STAFF RECOMMENDATION
Ransom Avenue/Byron Close Development
101 Ransom Avenue, Lot 1
August 19, 2015

Application: New construction--infill
District: Elmington Place Neighborhood Conservation Zoning Overlay
Council District: 25
Map and Parcel Numbers: 104100000100CO
Applicant: Barlow Builders
Project Lead: Melissa Baldock, melissa.baldock@nashville.gov

Figure 1. Site map.

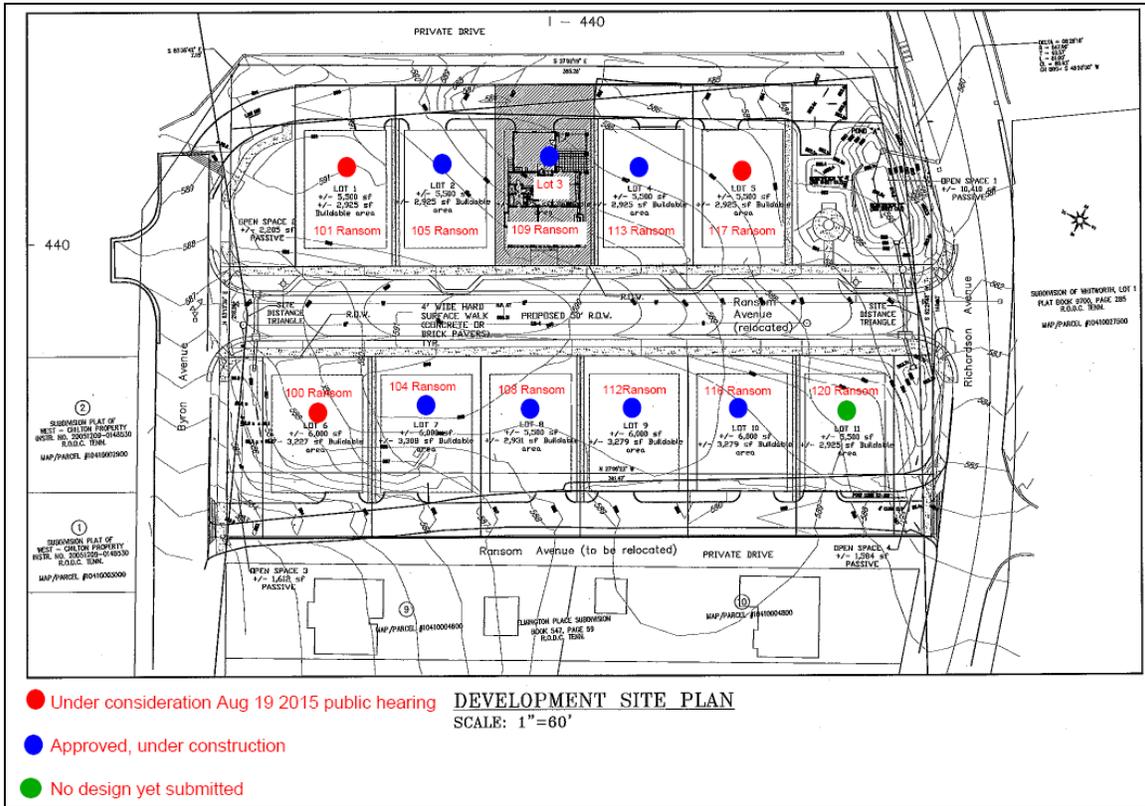
Background: Ransom Avenue/Byron Close is an eleven unit residential SP development (BL2008-149) located on the previous site of Ransom School, close to I-440 and West End Avenue. To date, the Commission has reviewed and approved the design of seven of the eleven houses (Figure 1). Construction on these houses has begun (Figures 2 & 3). The applicant now proposes designs for three more of the infill developments.

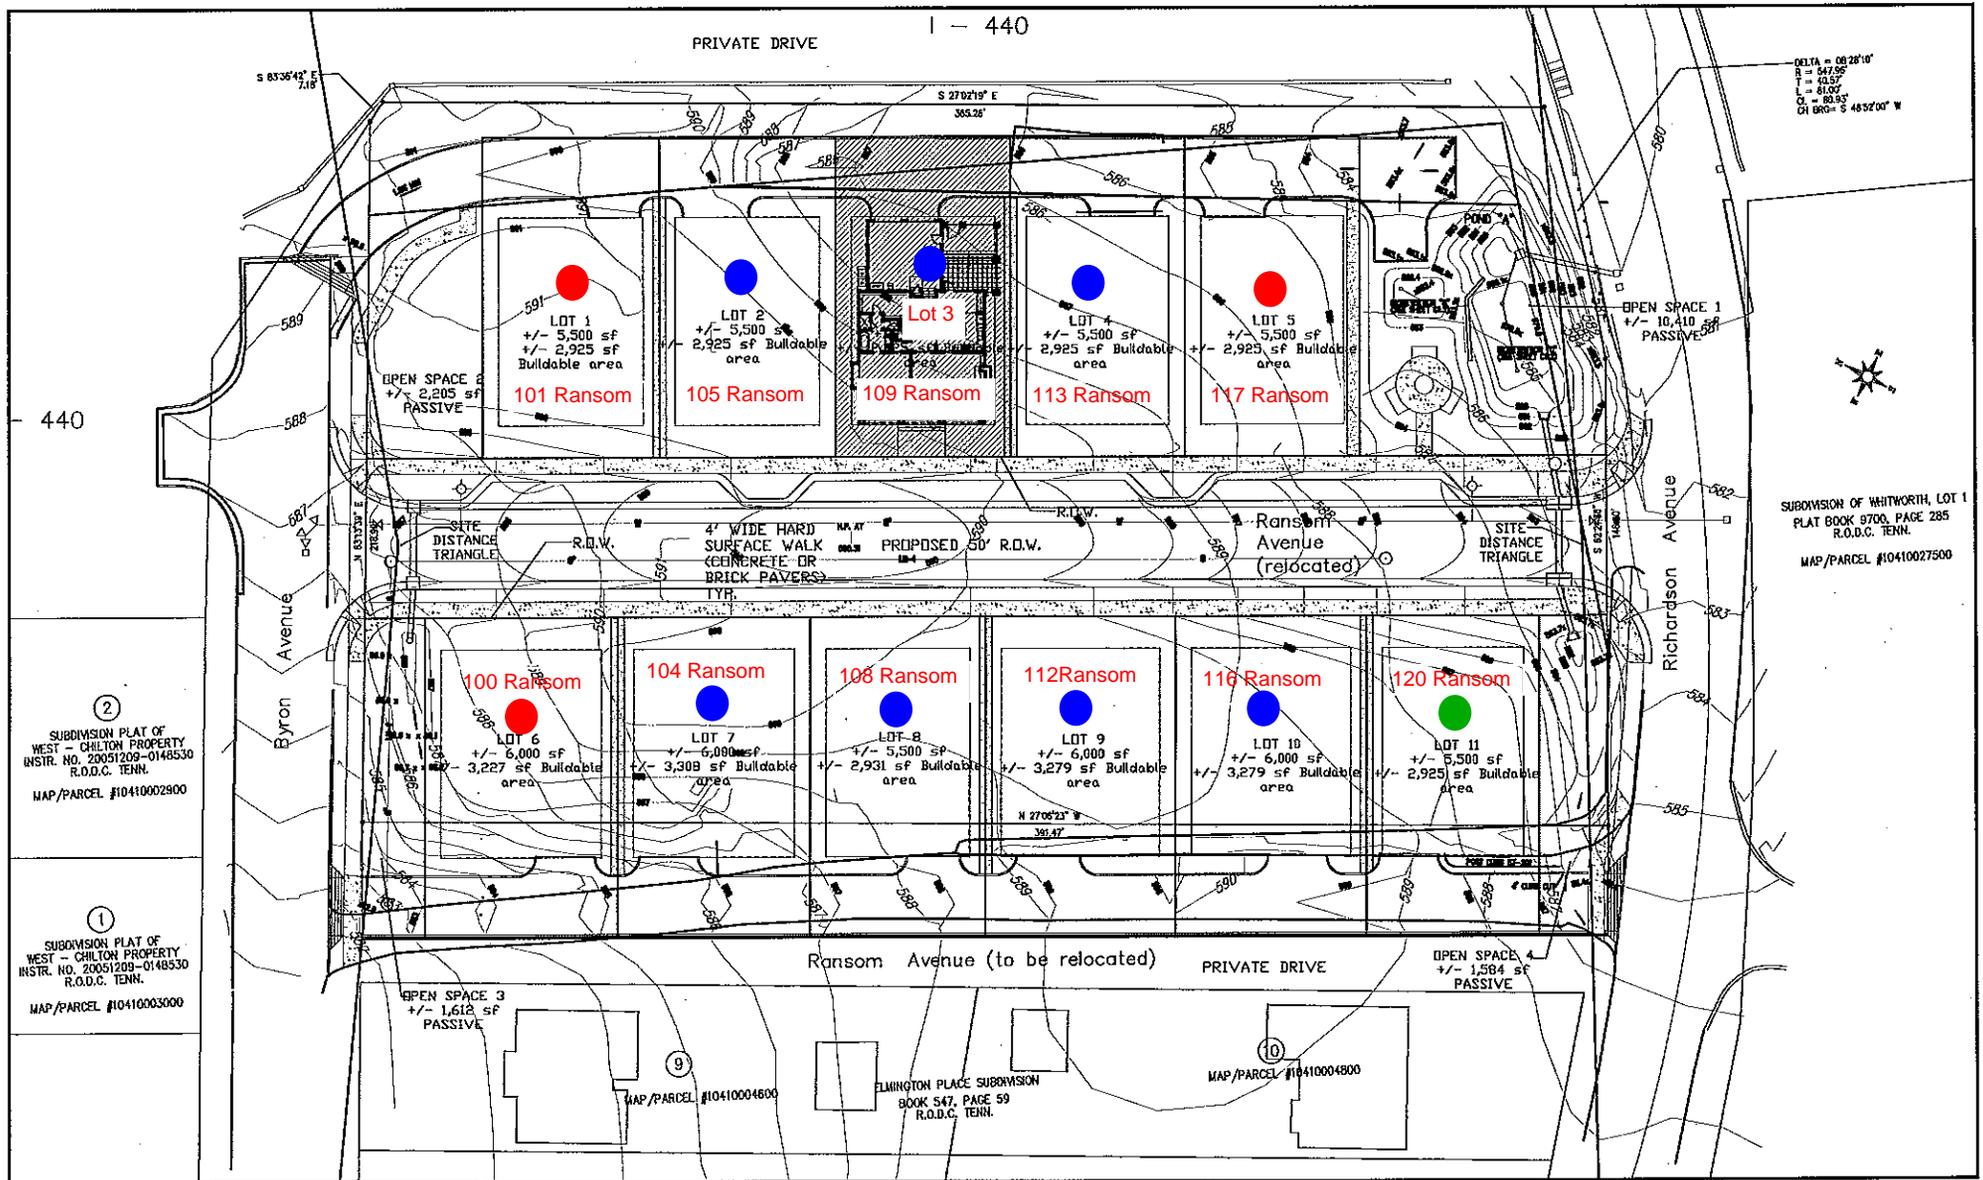
Orientation: Lot 1 is located on the edge of the Ransom Avenue development, with side facades that face Byron Avenue. The Commission has determined in the past that these lots should have side street facades that look like front facades in order to address Byron Avenue. Staff finds that Lot 1 does not adequately address Byron Avenue. The porch that wraps from the Ransom Avenue façade to the Byron Avenue façade does not have the appearance of a primary entry on Byron Avenue façade. This façade contains two porches, separated by a central protruding bay, and neither porch visually serves as a primary entry.

Vehicular access will be from the rear, accessed by a rear alley. There is a walkway leading from Ransom Avenue to the entryway, which is appropriate.

Staff finds that the orientation of Lot 1 does not meet Section II.B.1.f. of the design guidelines.

Recommendation Summary: Staff recommends disapproval of the infill for Lot 1, 101 Ransom Avenue, finding that its orientation does not appropriately address Byron Avenue, does not meet Section II.B.1.f. of the design guidelines, and does not match the agreement of the developer to include two primary facades on corner lots.

SITE PLAN

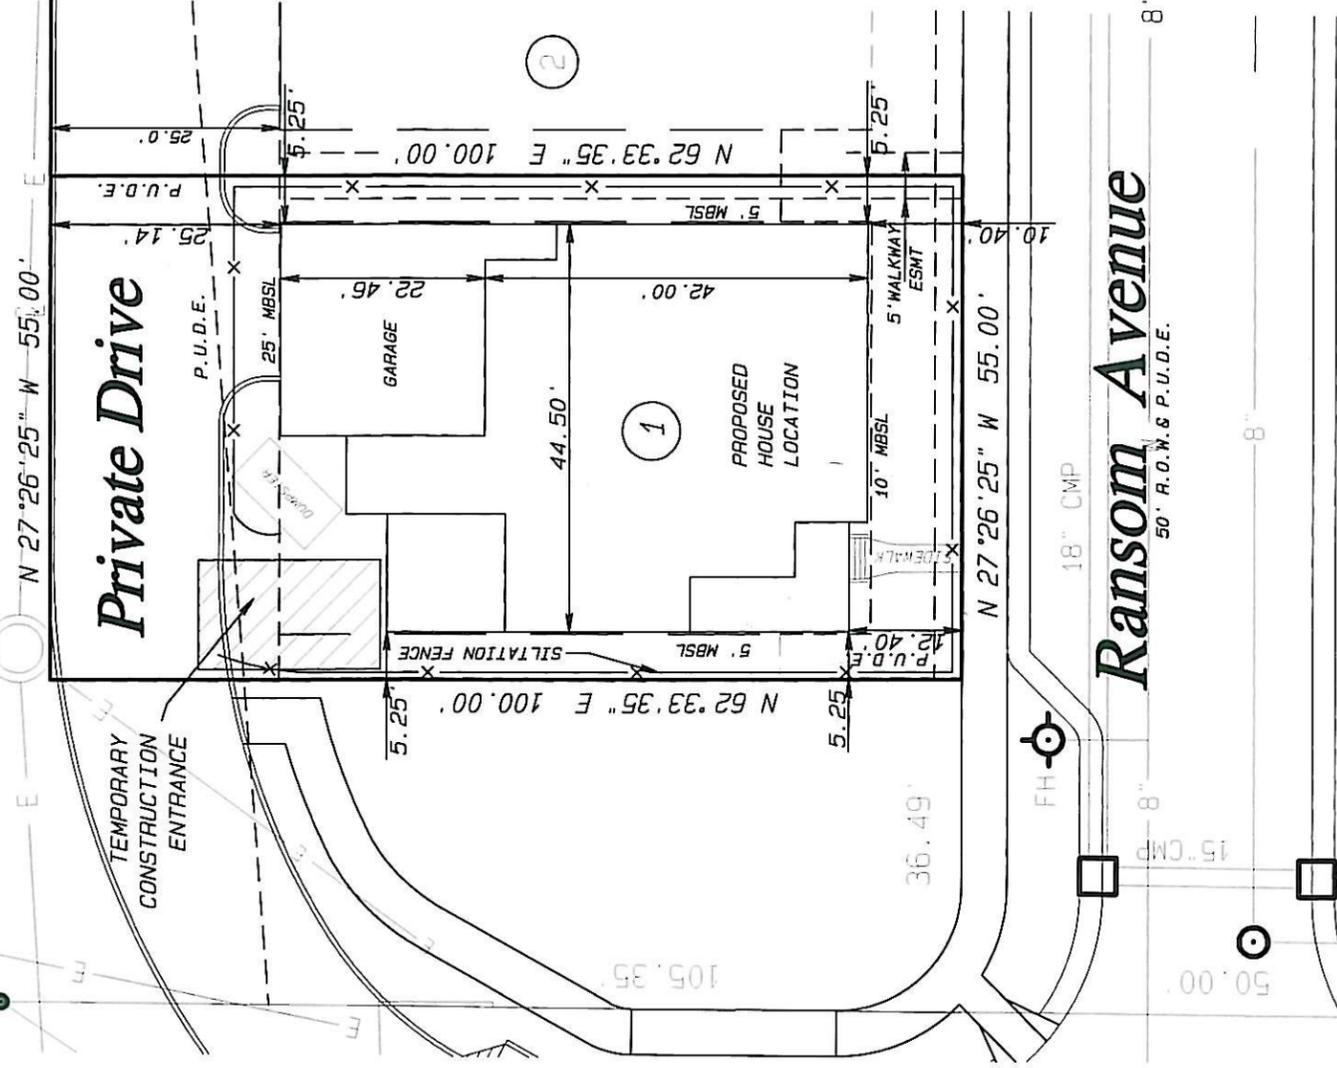
The house will have similar setbacks that were approved as part of the development plan in 2012. The front setbacks will be approximately ten feet (10'), which the Commission has determined to be appropriate for this development in the past. The side setbacks will be a minimum of five feet (5'), and the rear setback will be a minimum of twenty-five feet (25'). These setbacks meet the development plan and have been approved by the Commission for infill in this development in the past. Staff therefore finds that the setbacks and rhythm of spacing meet section II.B.1.c. of the design guidelines.

Appurtenances & Utilities: The location of the HVAC and other utilities was not noted on the site plans, and staff asks that the HVAC units be located on the rear, or on a side façade beyond the midpoint of the house.
